**RE: 1 Liffey Wood, Liffey Valley Park, Lucan, Co. Dublin – proximity
to storm water sewer.
Register Reference: SD22B/0209**

9 January 2023

Figure 1 - Section through proposed development

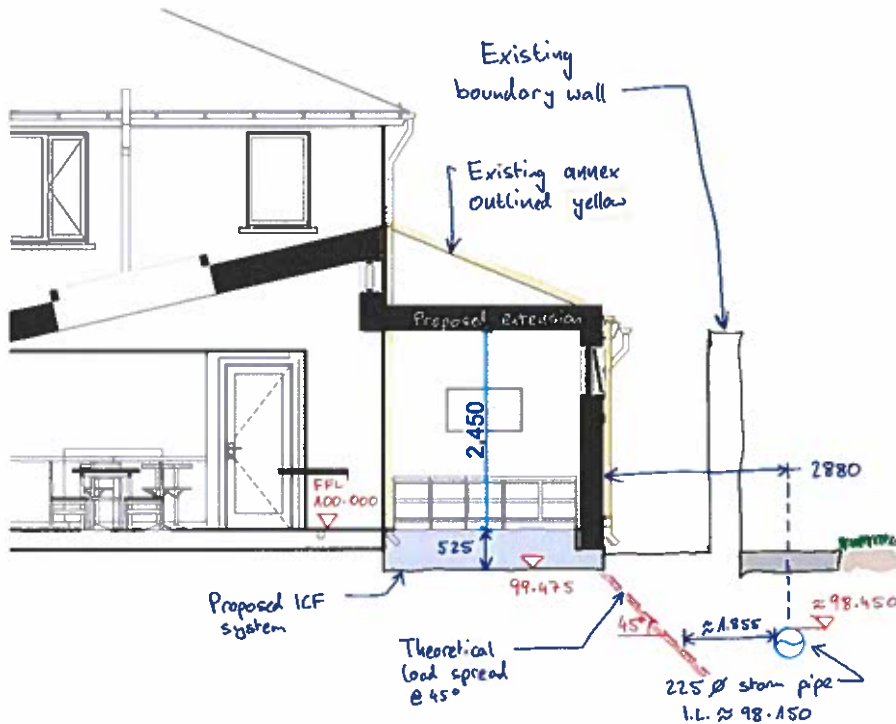
There is a 225mm diameter storm water pipe in the public footpath outside the boundary wall of the site of the proposed development. Based on my measurements at the site and the best information available to me, the cross section adjacent to the proposed development is as shown in Figure 1 and summarised as follows:

1. The centreline of the existing 225mm storm pipe is approx. 2880mm from the wall of the existing annex and the proposed extension at the property.
2. Taking finished floor level as a local datum of 100.000m, the invert level of the pipe is approx. 98.150m adjacent the proposed development.
3. The proposed development will be on a 525mm thick Insulated Concrete Formwork (ICF) foundation system with sub-formation at approx. 99.475m relative to local datum.

Based on this, I am satisfied that the proposed development will comply with Condition 2(b) of the Second Schedule to the planning decision, as, taking a theoretical angle of load spread of 45° , there will be no transfer of load from the proposed foundation to the 225mm storm water pipeline. This is shown by the red line in Figure 1 and the dimension of $\approx 1.855\text{m}$, which is the spacing between the loaded area and my best estimate of the position of the pipeline.

- (i) the pipe is in the footpath outside the boundary wall, hence the development won't affect access to the pipe for maintenance,
- (ii) the existing annex to the property (outlined in yellow in Figure 1) has been standing at the same distance from the pipeline for many years without reported problems, and
- (iii) the proposed timber framed development on an ICF foundation is a light structure and transfers low loading to the ground.
